Our reference: MGLA240124-4964

Our ref: 2023/0837/S1
Your ref: 23/01304/FULEIA
Date: 5 February 2024

London Wall West

**London Wall West
Request for Pre-Planning Application Advice (Level 2)**

Image 2: Existing and proposed development from Bankside opposite Tate Modern

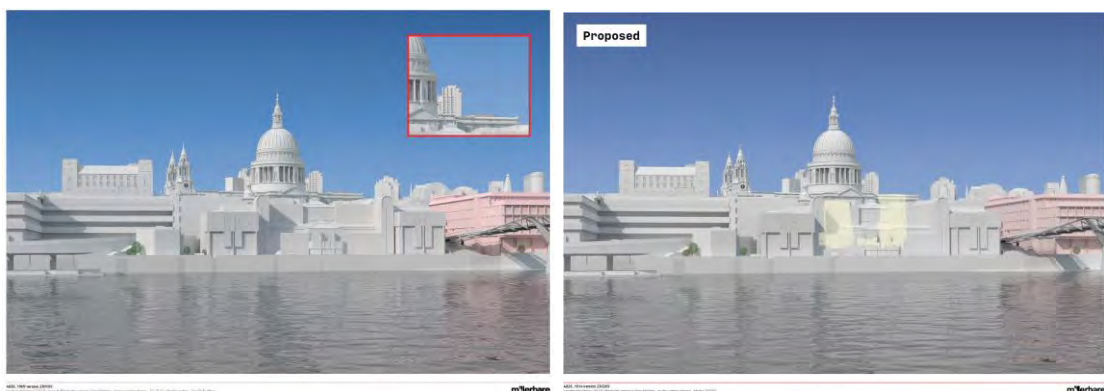
30. The applicant has provided a series of draft views from the surrounding area which demonstrate the potential visual impact of the proposed development from a series of viewpoints agreed with the City Corporation. The selection of viewpoints appear satisfactory to GLA officers at this stage. GLA officer comments on the current proposals in the views provided are offered below:
 - The view from Bankside opposite Tate Modern – at the viewing plaque. The proposed development is just breaking the parapet of St Paul's Cathedral. It is suggested that a minor reduction be made in the height of the building to remove this potentially harmful effect.

- The view north along St Martin's-le-Grand shows the Rotunda in the context of the Church of St Botolph. There is an increase in height relative to the existing condition, however, the proposed building appears appropriate in this view, in the context of the cumulative impact on the setting of this building by existing taller buildings.
